**Planning and Zoning Commission**

**Resolution No. 2022-021**

***Title 21 Text Amendment to Off-Street Parking  
and Site Access Regulations***

## Comment-and-Issue-Response Summary – Reflects June 6, 2022, PZC Deliberations and Approval

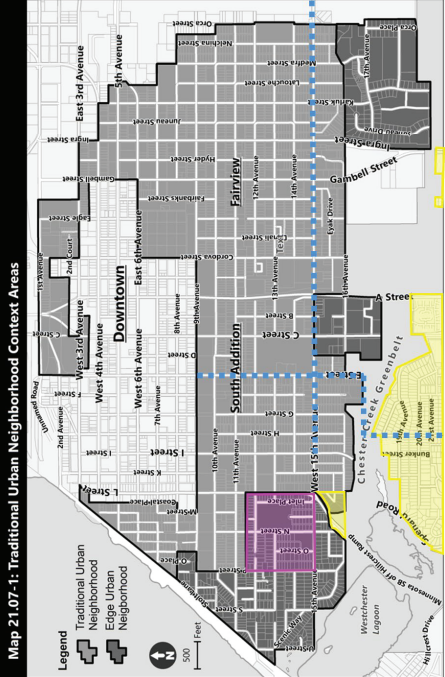
Item #	Comment/Question	Response and Recommendation	PZC Action (6-6-2022)															
<b>Part B: More Complete Menu of Parking Reduction Strategies</b>																		
4.	<p><b>Parking Reductions for Shared Vehicle Programs.</b>                      Traffic Engineering is supportive of the revised menu of available parking alternative strategies to include the addition of newer rideshare programs. (<i>MOA Traffic Engineering Department</i>)                      Whereas the amendments propose a 5% reduction in parking minimums if the property owner participates in a rideshare program, a 10% reduction if the owner includes free transit passes, and a 2% reduction if the owner provides a public transit stop or shelter, and whereas the Public Transportation Department offers rideshare and free transit pass programs for organizations to offer to their constituents, the Anchorage Public Transit Advisory Board supports the amendments as written. (<i>Anchorage Public Transit Advisory Board</i>)</p>	<p><b>Response:</b> The project team appreciates these comments, resolution of support, and multiple consultations with Traffic Engineering and Public Transportation Departments that informed the updated menu of parking reductions in Table 21.07-9 for shared vehicle and high-occupancy vehicle (HOV) programs.                      Public Transportation staff has requested that the Title 21 parking reduction for rideshare programs be offered to property owners and employers who participate in the program but may only partially subsidize the cost. Of the approximately 18 employers that participate in the municipal rideshare (vanpool) program, only one fully covers the cost for its employees to participate. Other employers partially subsidize, and the remainder is grant funded by the rideshare program.  <b>RECOMMENDATION:</b> Amend Table 21.07-9, Rideshare Program, (page 32 in Attachment 3) as follows:</p>

<table><tr> <th colspan="3" data-bbox="760 310 824 1423">Table 21.07-9: Parking Reductions and Alternatives</th> </tr><tr> <td data-bbox="1019 310 1052 583"></td> <td data-bbox="1019 583 1052 926"></td> <td data-bbox="1019 926 1101 1423">Each rideshare space may count as six spaces toward meeting the minimum number of required parking spaces, up to a 5% reduction in the number of required parking spaces.</td> </tr></table>

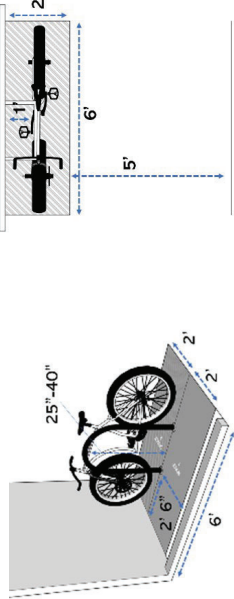
Item #	Comment/Question	Response and Recommendation	PZC Action (6-6-2022)																
21.	<p><b>Maximum Front Setbacks.</b></p> <p>Table 21.07-2 sets the proposed Pedestrian Frontage Standards for Traditional Urban Neighborhood Contexts including South Addition. The maximum setback in the table is a tenuous concept for South Addition, for several reasons. It does not provide specific exemptions for properties. It does not address existing, older residential buildings that may be remodeled. It does not address lots that are located along the Chester Creek bluff in South Addition and Fairview, especially lots without alley access. Similar bluff conditions exist in Mountain View and Government Hill as well. The lots in Traditional Urban Neighborhoods are smaller and need to allow the designers to use their best judgement to locate buildings on the lot. For example, a west or south facing frontage may want to pull the building back all the way towards the back where garage access exists from the alley. Such building can still have "eyes on the street" (i.e., street-facing windows, entries, and living spaces) even if it is set back farther. The most important feature to avoid on the street is large garage frontages. <i>(South Addition Community Council Planning Subcommittee)</i></p> <p>Will a porch, stoop, or landing sheltered by a roof count towards meeting the maximum front setback requirements?</p> <p>Will the porch be allowed to project into the minimum front setback? <i>(Connor Scher)</i></p>	<p><b>Response:</b> No objection to removing the maximum setback from the low- to medium-density residential zoning districts. The maximum setback is more important in the urban commercial districts, mixed-use corridors, and high-density R-4 residential district. (Maximum setbacks in the R-4A district are addressed in the R-4A district-specific standards.) The proposed maximum setbacks are carried over from current code for mixed-use development in the commercial districts, as well as from the current Title 21 approval criteria for area-specific parking reductions. Fairview Community Council in consultations emphasized that buildings should be required to be set close to the street, as called for in the <i>Fairview Neighborhood Plan</i>. The <i>Spennard Corridor Plan</i> also calls for pedestrian-oriented building placement.</p> <p>Maximum setback regulations in Title 21 address existing buildings. The general provisions for maximum setbacks in Section 21.06.030C.5 recognize that existing buildings may remain legally out of compliance. The maximum front setback applies to the building elevation wall. Covered entry porches but not stoops or landings may also count toward meeting a maximum front setback. Because the maximum front setback is 10 to 20 feet larger than the minimum front setback and applies to no more than 50% of the building facade width, there is plenty of space between the max. and min. to avoid a "catch-22" situation for front stoops.</p> <p><b>RECOMMENDATION:</b> Amend Section 21.07.060F.3, Table 21.07-2 (page 14 of Attachment 3), in row "A," and delete footnote 4, as shown below. (Also delete the references to footnote 4 from rows B and G.)</p>

<table><tr> <th colspan="2">Table 21.07-2: Pedestrian Frontage Standard for Urban Neighborhood Contexts and Parking Reductions Building and Parking Placement<sup>1</sup></th> <th>Primary Frontage</th> <th>Secondary Frontage</th> </tr><tr> <td colspan="4">1. DEVELOPMENT IN THE R-4A ZONING DISTRICT IS EXEMPT FROM THE MAXIMUM SETBACK RELATED STANDARDS A, B, AND G1</td> </tr></table>

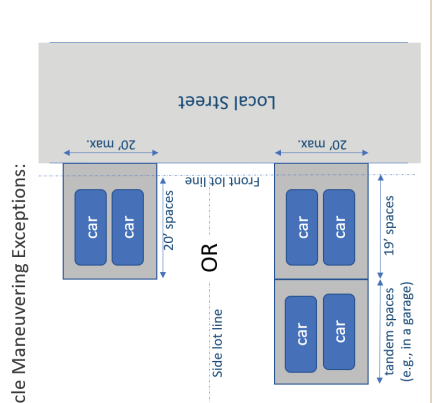
36.	<p><b>Determining which Parking Spaces on a Site Plan are Eligible for Small Dimensions.</b></p> <p>Traffic Engineering is appreciative of the changes made to the parking angle, stall, and aisle dimensions, however has concerns with proposed exception 21.07.090H12.a.i. (Page 58 in Attachment 3) that allows for 50% of spaces to be smaller dimensions for employee only, structured parking facilities, and low parking uses. This provision may need additional</p>	<p><b>Response:</b> The comment comprises three main questions:</p> <ol style="list-style-type: none"> <li>1. What defines low turnover uses;</li> <li>2. How are the spaces for low turnover uses to be identified; and</li> <li>3. Can the Municipality require them to be called out in a parking study on the plan?</li> </ol> <p>The second and third questions are addressed during the permitting approval process for the site plan. The proposed parking layout site plan should identify which spaces serve low-turnover uses and have smaller dimensions. If the low-turnover parking spaces are not shown on the site plan, and the parking study (if there</p>	<p><b>Approved the Recommended Change</b></p>

Item #	Comment/Question	Response and Recommendation	PZC Action (6-6-2022)
	<p>clarification regarding which spaces on a site plan are designated as either employee only or low turnover for both municipal staff who review plans and design professional that develop the site plan. (MOA Traffic Engineering Department)</p>	<p>is one) does not address the number of spaces, then that should be a permit reviewer comment. Asking for clarification on a parking layout plan or site plan is common practice by zoning plan reviewers.</p> <p>The answer to question 1 above seems apparent in the second sentence in 21.07.090H12.a.ii. (Attachment 3, page 58, lines 27-30). However, perhaps a simple word change, as provided below, could make it clearer.</p> <p><b>RECOMMENDATION:</b> Clarify proposed subsection 21.07.090H12.a.ii. (Page 58, lines 27-30, in Attachment 3) as follows:</p> <p>Uses with a low parking turnover rate are [COMPRISE] multifamily and mixed-use household living uses, office uses, and educational facility uses other than instructional services.</p>
